Request for Clarifications: #3

Halcyon Phase 2 Buildings 1100 & 1300

5  
S-0.03

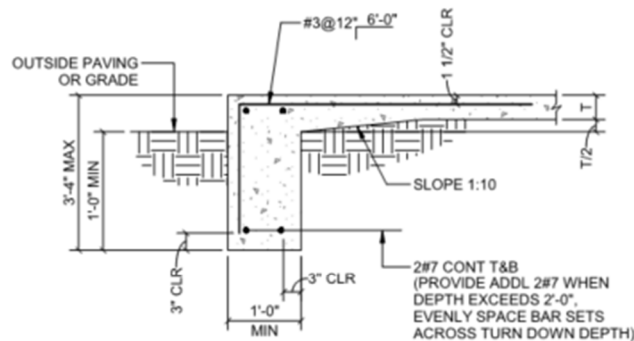
1. There is no detail for the proposed turndown sidewalk on sheet C2-01. Please provide detail.  
**AJCC: Use detail 5/S0.03**

**TYPICAL SLAB ON GRADE TURN DOWN**
